Request for Change Order

La Vernia ISD 2023 Bond Projects (**231091**)

No. RCO0125

Description	PR#70 - HS Cafe Delivery Route	Date	2026-10-05
Status:	Pending Review	Days Impact:

DIMENSIONAL CONTROL PLAN - HIGH SCHOOL

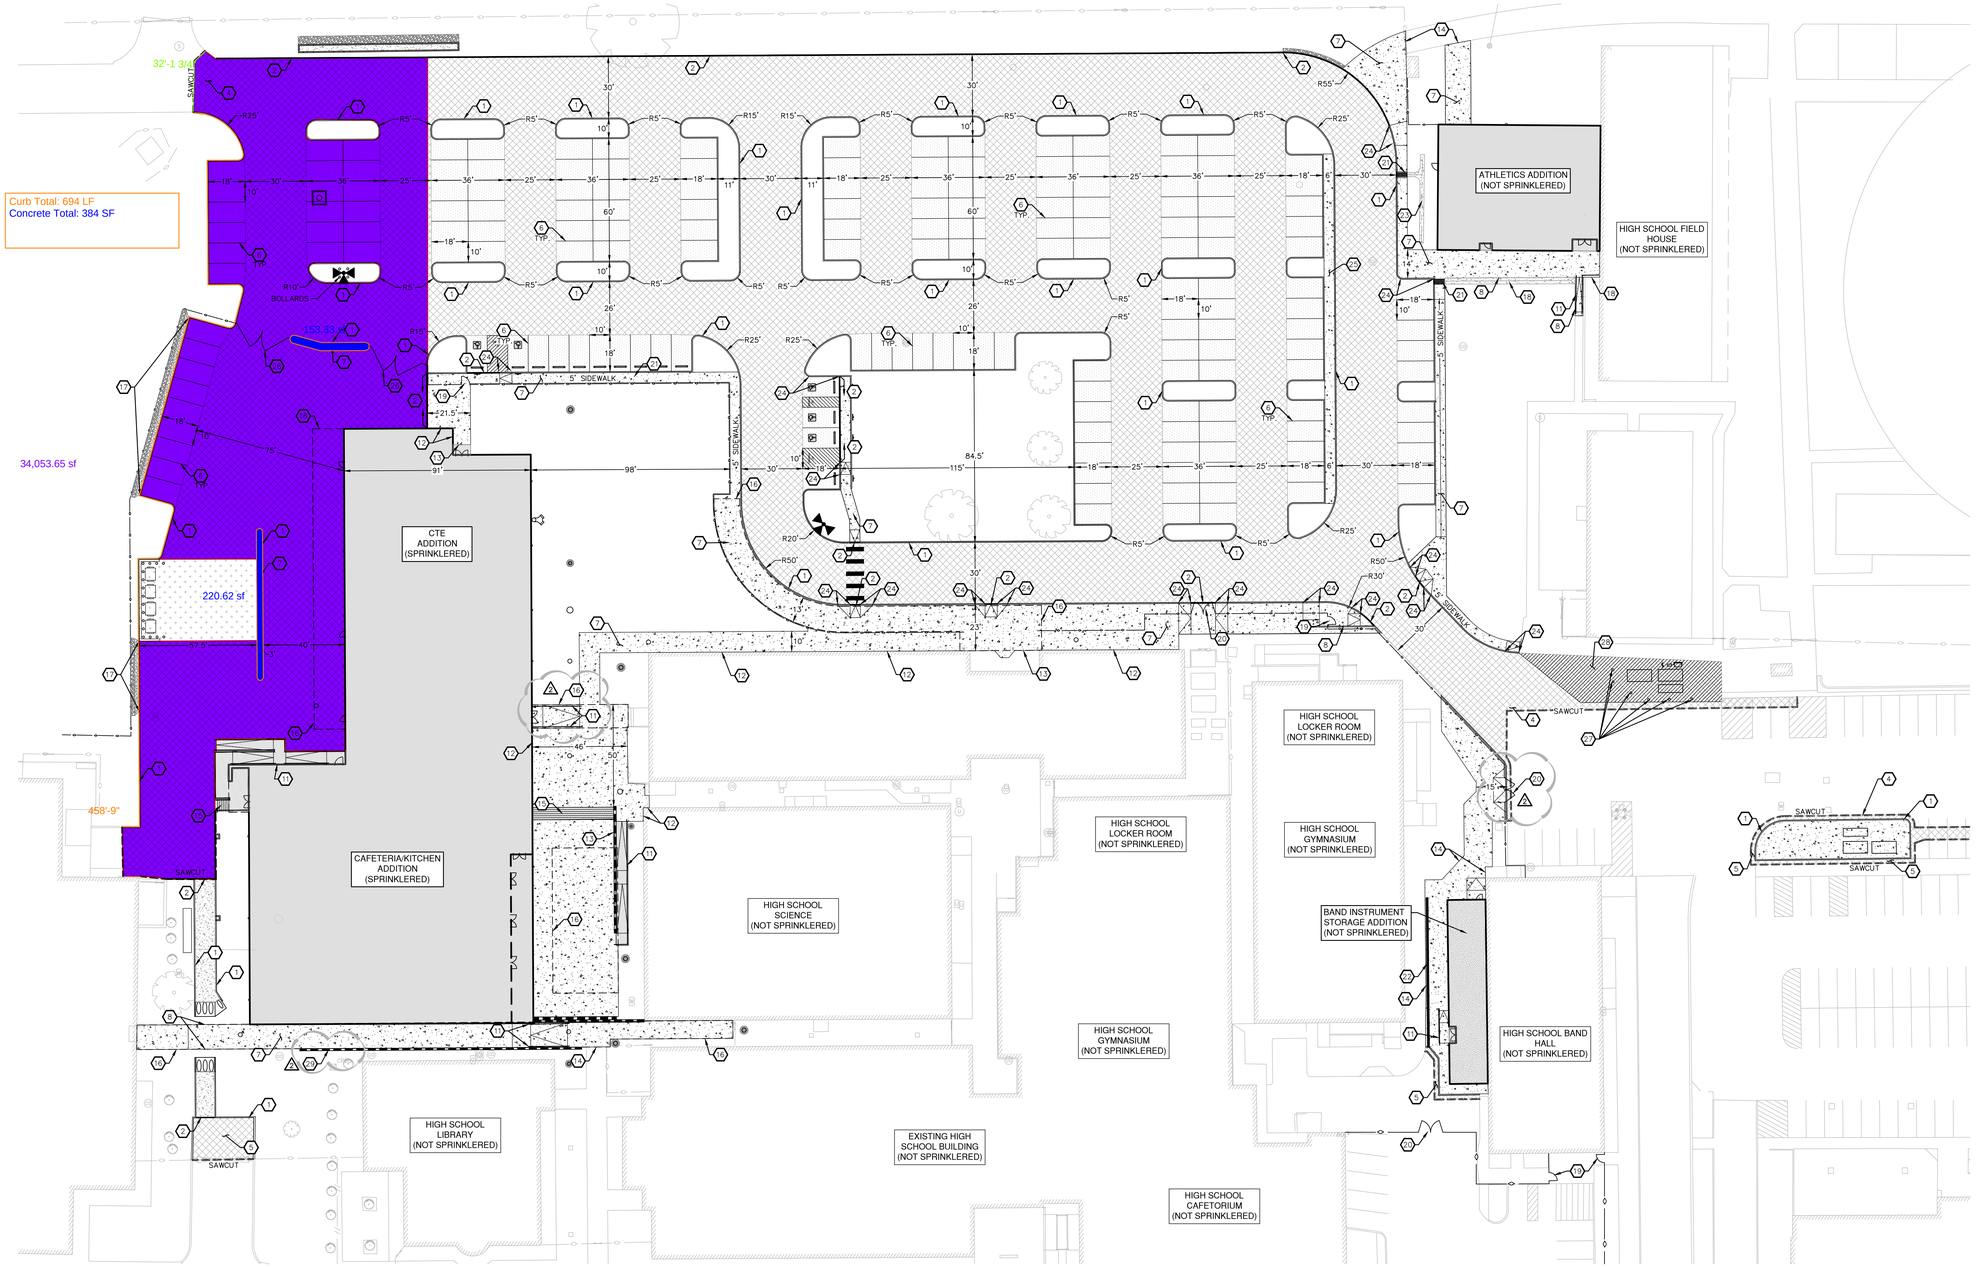
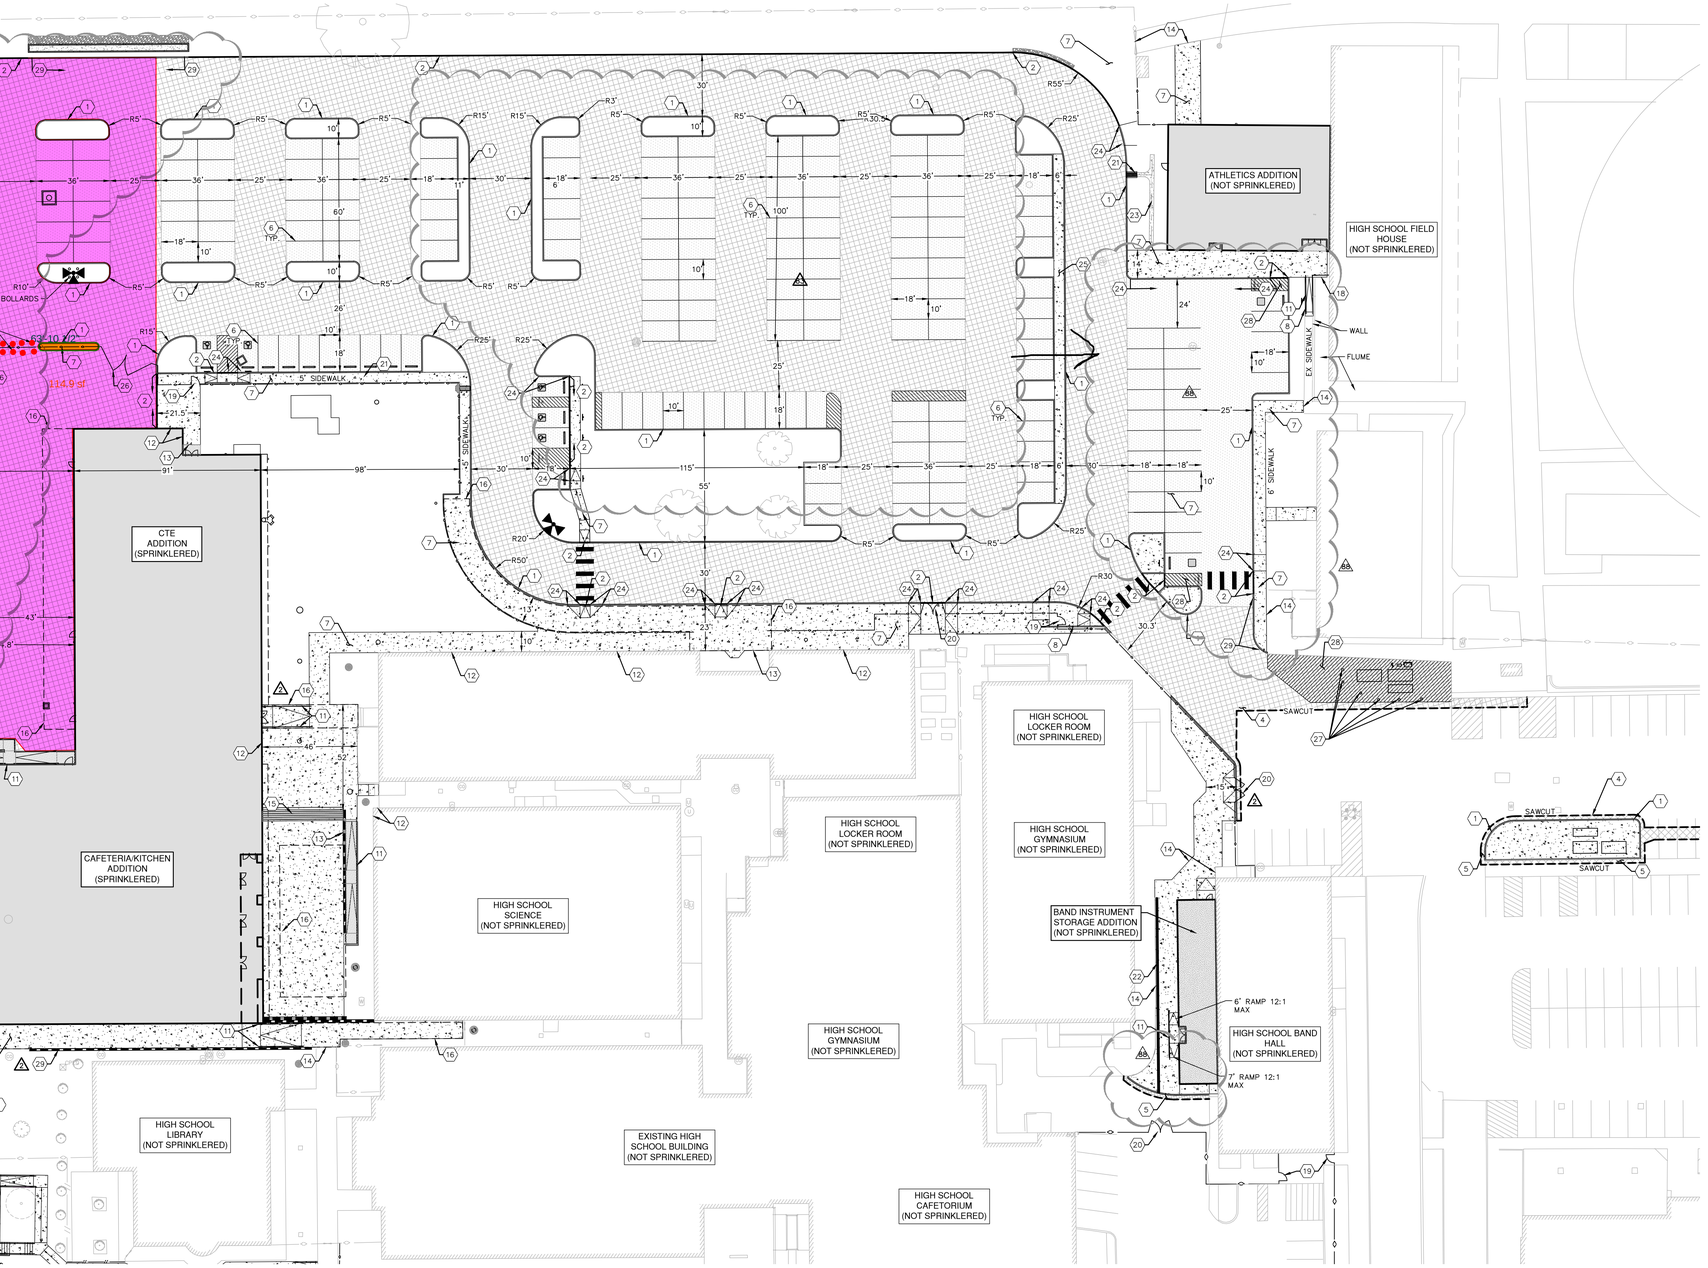
Page 4 shows base bid square footages for asphalt, concrete, etc.

Page 5 shows new scope displaying the overall add of asphalt and the bollards.

The concrete scope was a zero-dollar change. The amount of curb/concrete credited equaled the amount of concrete scope added (Curb, flatwork, bollard installation).

OVERALL SITE PLAN

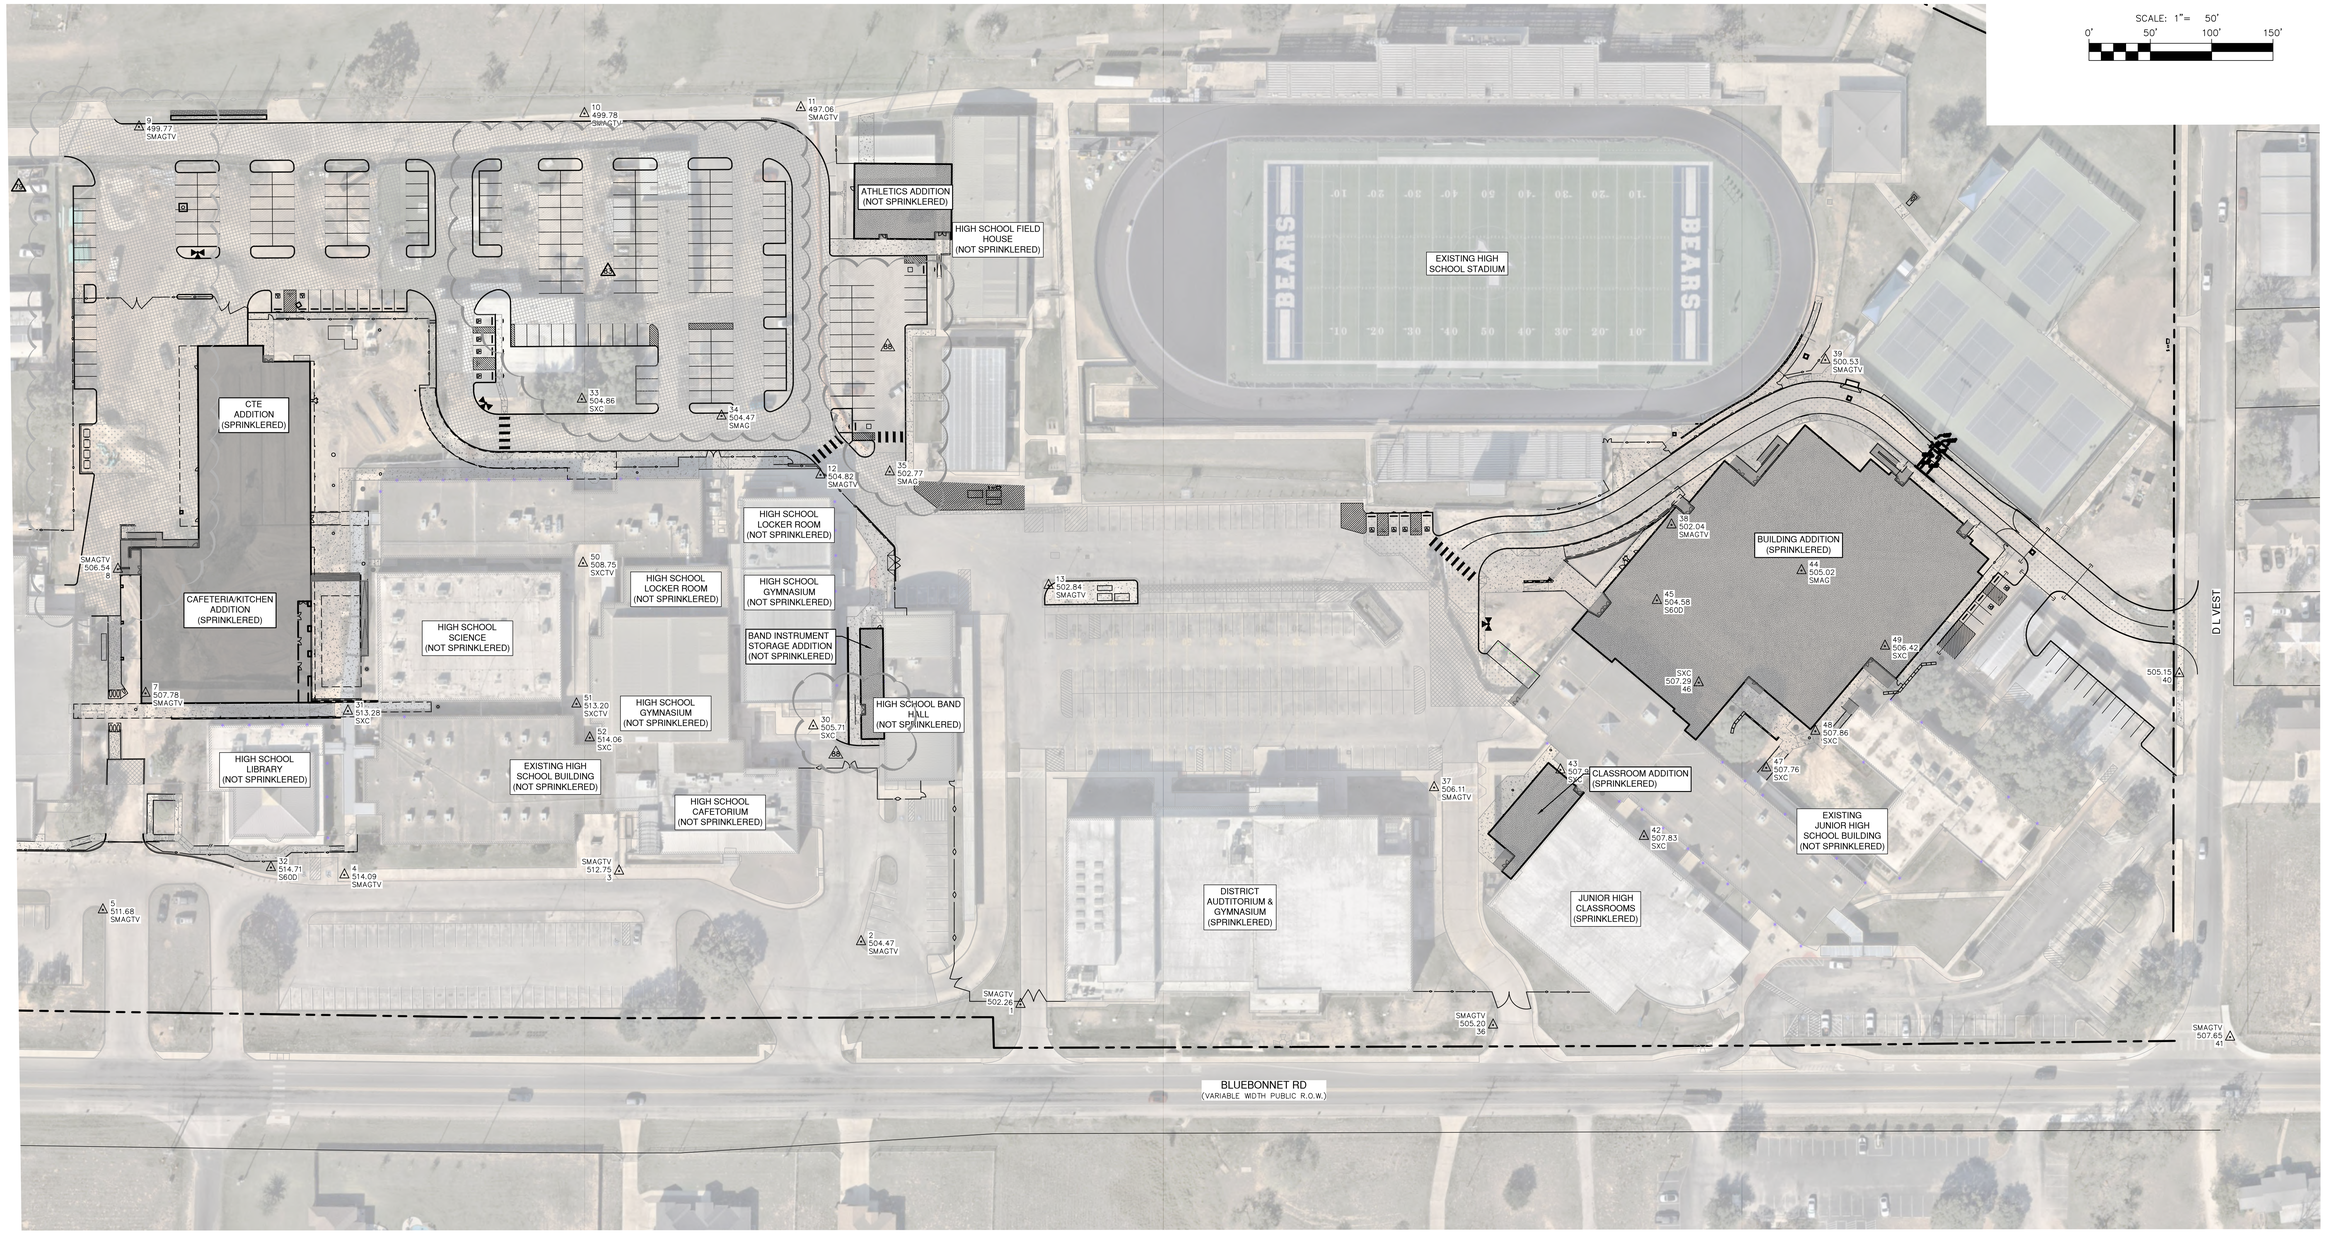
The sheets below, associated with PR No. 70, were revised in response to the owner's request to widen drive lane along the west side of the high school. The following sheets are included with this change.

- Package 2 C1.00 – Updated site layout to widen drive along west side of high school.
- Package 2 C1.01 – Updated demolition limits at drivel.
- Package 2 C1.10 – Updated fire lane, gate with Knox lock, and hose lays in response to widening the drive lanes.
- Package 2 C2.00 – Updated silt fence along the west side of the high school in response to widening the drive lane.
- Package 2 C3.00 – Updated dimensions and callouts to reflect the new widened drive lane. Added bollards to protect updated fencing/gate. Removed sawtooth curbing with apron.
- Package 2 C4.00 – Updated grade contours in response to widening the drive.
- Package 2 C4.01 – Updated contours and elevation spots in response to widening the drive lane.
- Package 2 C5.00 – Updated contours.
